Site Plan Review File # 22-116-859

- **LOCATION:** 0 Madison St. (N of 2319 W 7th St. and St. Paul Avenue)
- **APPLICANT:** Trellis Treehouse Acquisition LLC
- **HEARING DATE:** December 1, 2022
- **DATE RECEIVED:** August 23, 2022
- **PLANNING COMMISSION DECISION:** December 9, 2022
- **DEADLINE FOR ACTION:** February 20, 2023

DRAWING TITLE:
 SITE LAYOUT AND
 SURFACING PLAN

C401

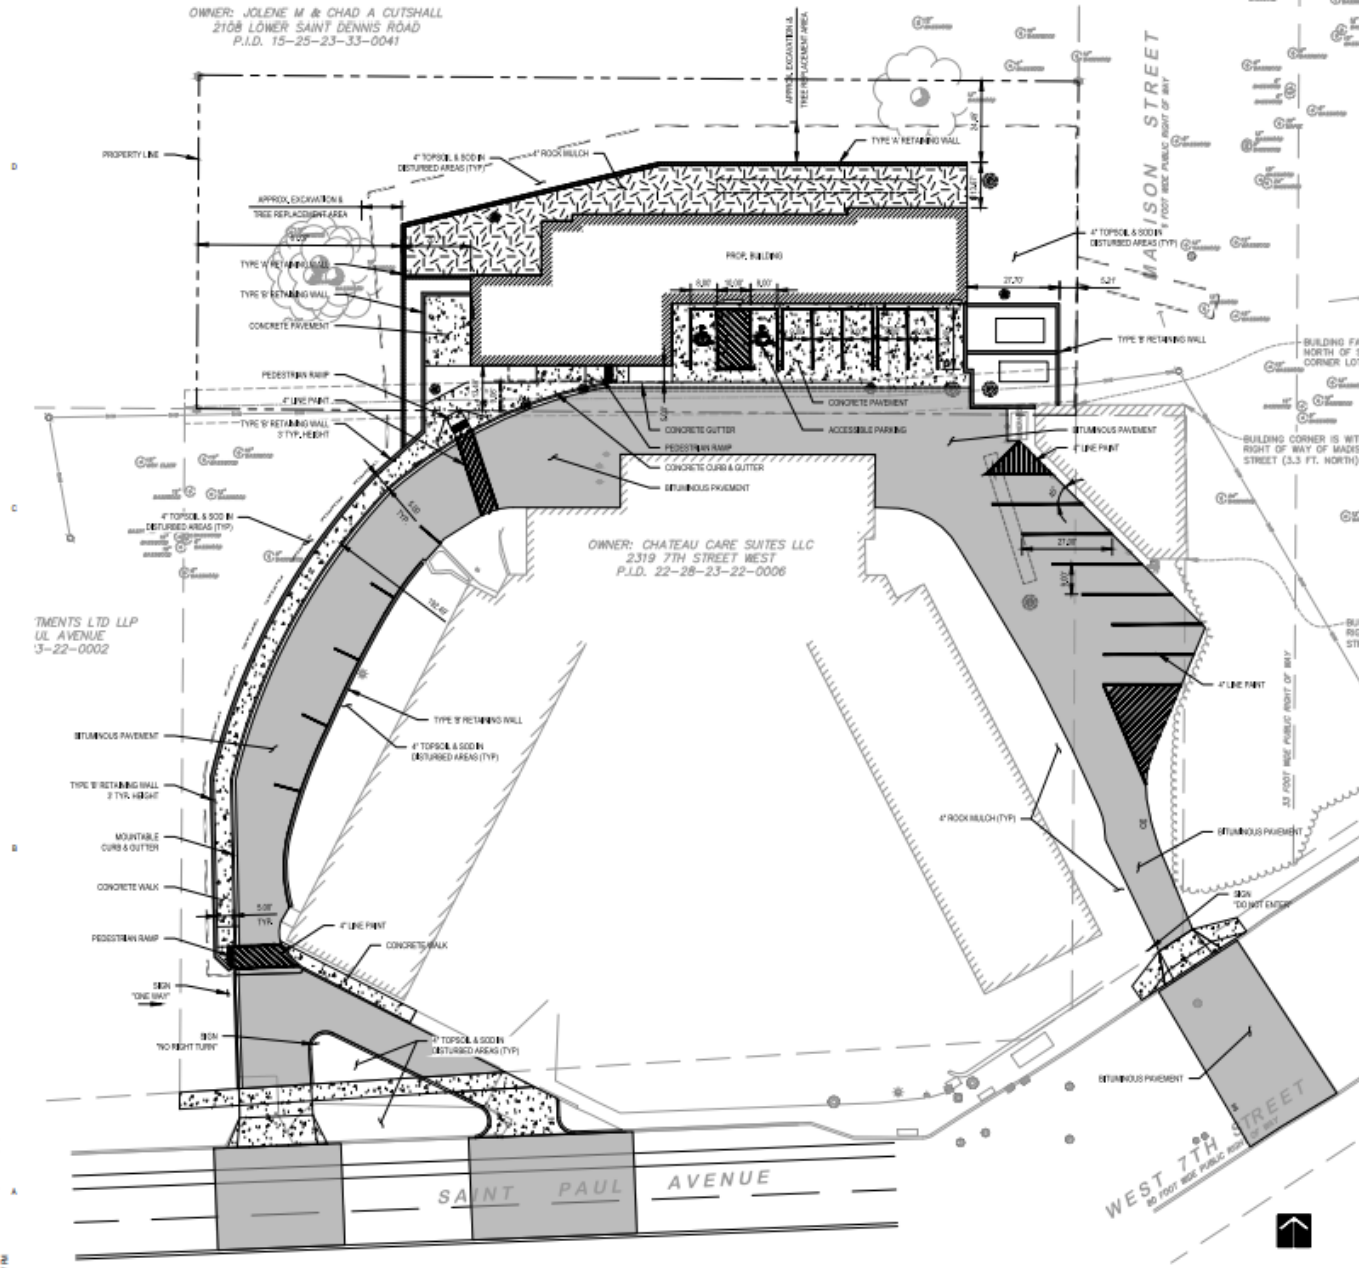
Safety and convenience of both vehicular and pedestrian traffic both within the site and in relation to access streets, including traffic circulation features, the locations and design of entrances and exits and parking areas within the site.

Physical improvements to the existing drive at Highland Chateau parcel provide access and public services via a private street with a reciprocal maintenance, use, and easement agreement. The existing one-way site circulation will continue with a vehicular entrance to the private street from West 7th Street and an exit onto St. Paul Avenue.

Improvements along the Highland Chateau's St Paul Avenue frontage are required per Public Works and Zoning to provide the safest possible scenario for all modes arriving at the site.

- The existing drive will become a private street.
- Widening the one-way access drive to give space for resident drop off, maneuvering isles, and trash pickup, emergency access etc.
- A public sidewalk added to the Highland Chateau parcel along St. Paul Ave.
- Sidewalk along St. Paul Ave. and the private drive will meet Minnesota Accessibility code
- Removal of existing encroachments in the ROW
- Minimize curb cuts and meet Public Works' standards for curb and driveway design.
- Room for passenger drop off will remain at the Chateau.

A traffic memo is under review by Public Works Traffic Engineering. Public Works sign-off of the site plan and acceptance of the traffic memo are recommended conditions of site plan approval.

1. **Sign-off by Site Plan Review staff for technical compliance of the site plan** that is substantially similar to this approved site plan.
2. **Approval of a variance** of 63.111(b) to allow the proposed retaining walls and creation of trough-shaped yards between the new building and new retaining walls.

3. **Approval of rezoning** of the property from R1 – one-family residential district to RM2 - medium-density multiple-family residential district.
4. **A private street to serve the development** must be established. The private street must be established based upon a plan submitted to and approved by both the Department of Public Works and the Department of Safety and Inspections, Division of Fire Inspections, before final site plan approval.

63.111 – Residential Development on Steep Slopes

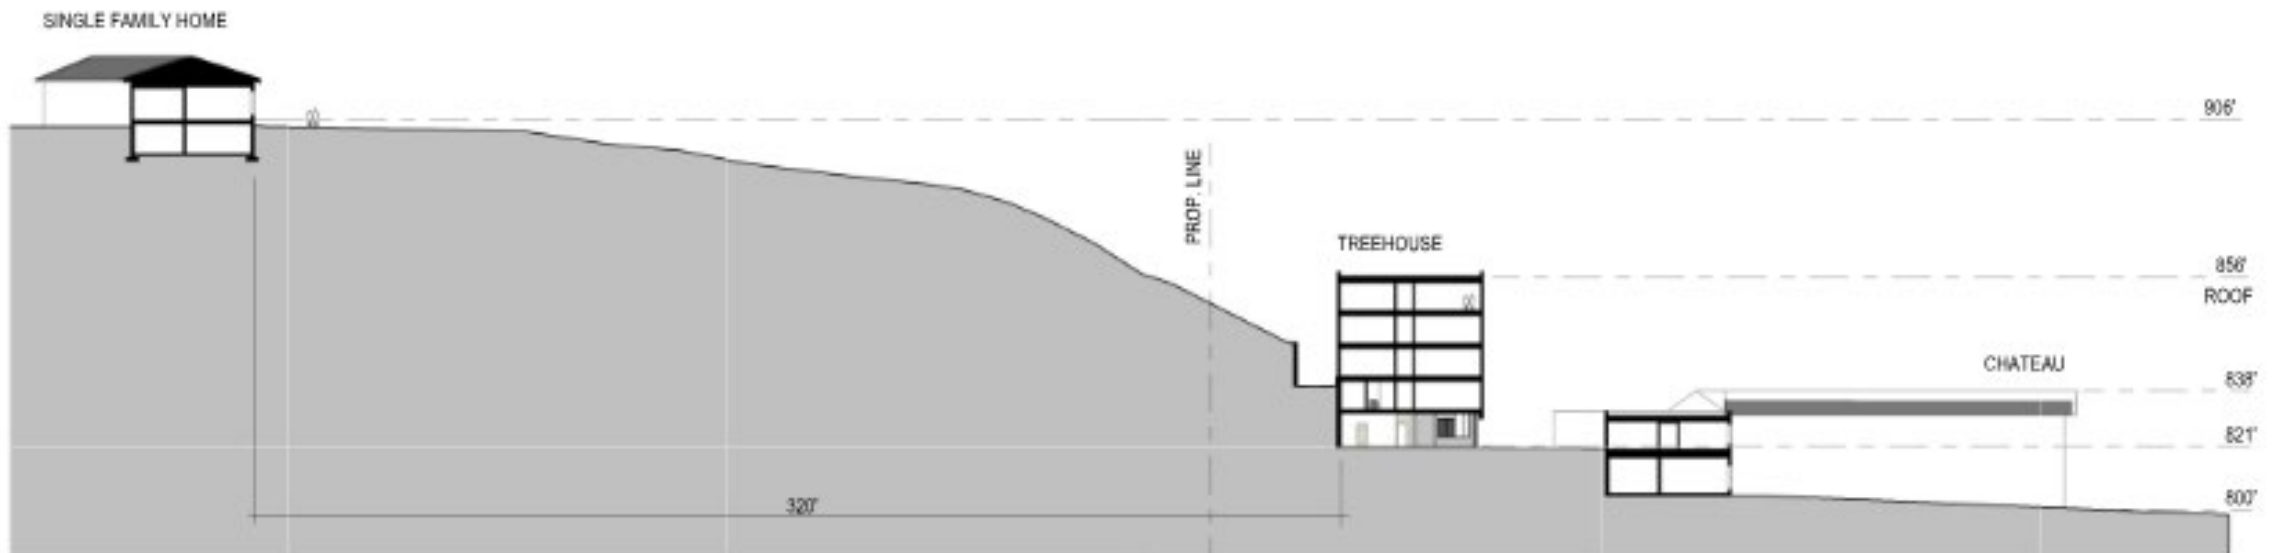
The proposed site plan requires a variance of Leg. Code Sec. 63.111 (b) before it may be established: Buildings should be designed to fit into the hillside without significant regrading to protect the stability of the slope and preserve existing trees while preventing excessively tall retaining walls and unattractive trough-shaped yards between buildings and retaining walls. Multi-story buildings are encouraged to reduce the size of the building footprint.
